**PCN-147945**

## **Product Change Notice**

Change of leadframe for ASMB-LTx2 and ASMB-LTx3

### **Description and Extent of Change:**

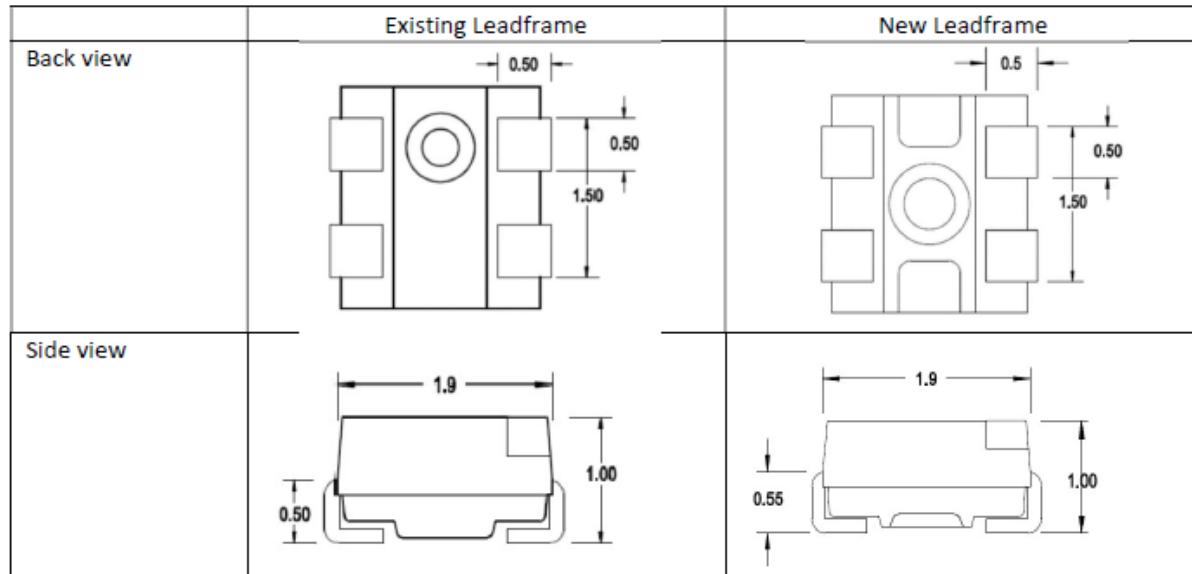
The new leadframe will replace the old leadframe for all the part numbers listed above

There will be no change in the function of the products. The changes in the fit and form of the final products are as illustrated below. Qualification and characterization have been conducted to ensure the quality and reliability of the final products are maintained.
